Service-Information

D-35 & D-50	January 27, 1984	Bulletin No. NA 0014

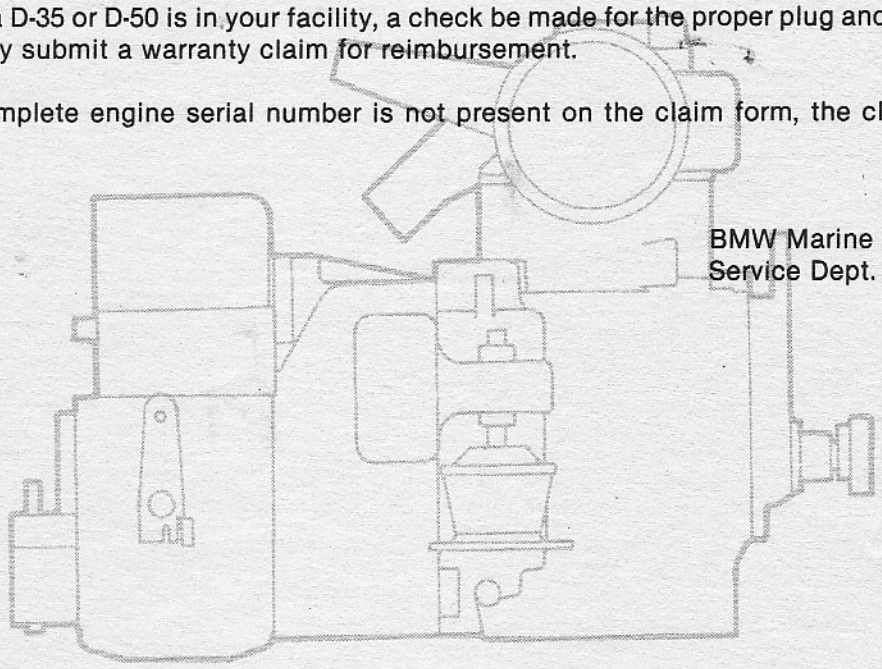
All freeze out plugs being installed in the D-35 and D-50 are now being made of stainless steel. When ordering these plugs, please use the following part numbers and correct your parts book accordingly:

We request that if a D-35 or D-50 is in your facility, a check be made for the proper plug and replaced if necessary. You may submit a warranty claim for reimbursement.

45mm Ø — 11 11 1 761 140

40mm Ø — 11 12 1 761 143

38mm Ø — 11 12 1 761 142

36mm Ø — 11 12 1 761 141
